Service Action S39810: ABS wiring

REF NO: TJ 32069.1.1	ISSUING DEPARTMENT: Technical Service	CAR MARKET: United States and Canada	
PARTNER: 3 US 7510 Volvo Car USA		ISSUE DATE: 2016-10-31	STATUS DATE: 2016-11-08
FUNC GROUP: 3700	FUNC DESC: Cables and fuses	Page 1 of 5

Title	S39810, ABS wiring	Page	1 (3)
Action	Inspection

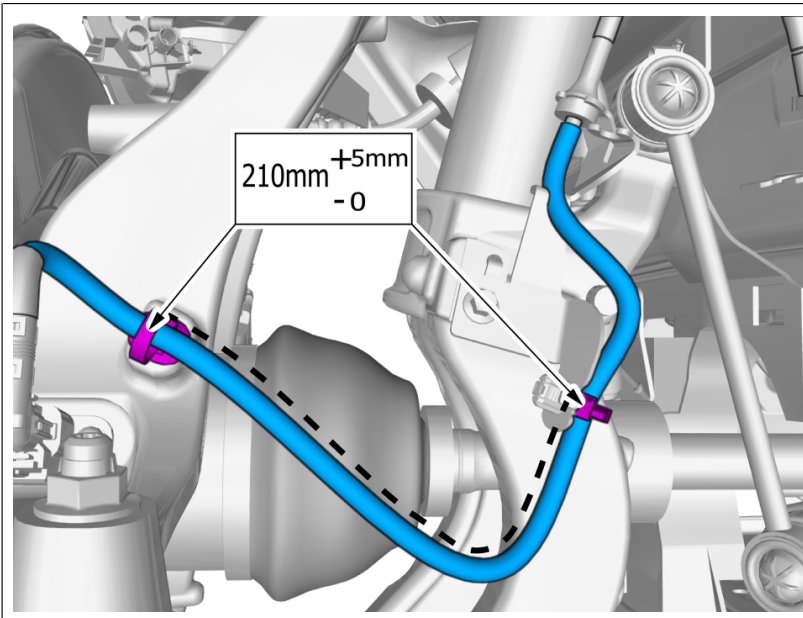
If the distance is less than 20mm, the wiring needs to be repositioned according to the following steps.

Remove the cable tie(s).

Use: Strip clamp , 983750

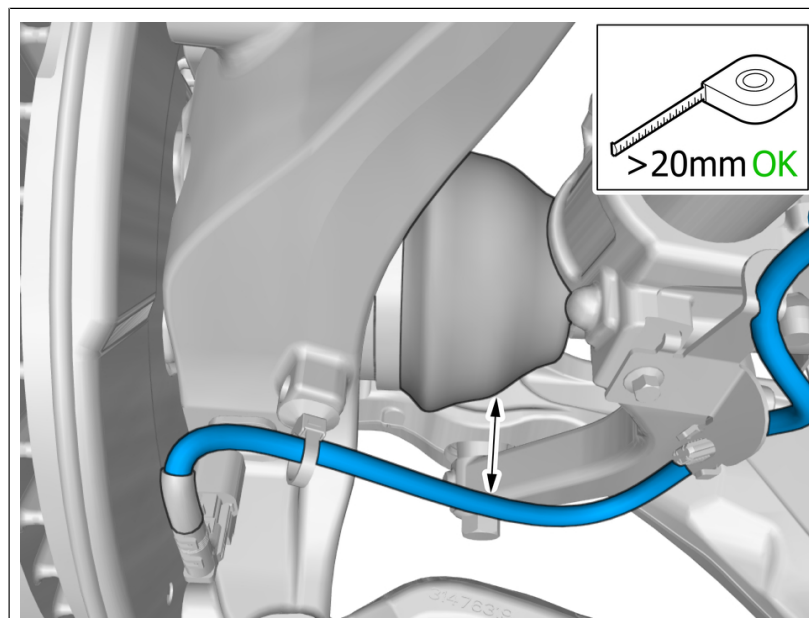
Adjust the wire length between the points indicated to 210 - 215 mm.

If necessary, twist the wiring slightly before installing to adjust the distance between the wiring and the axle.

Confirm the distance is now 20mm or more on both sides of the vehicle.
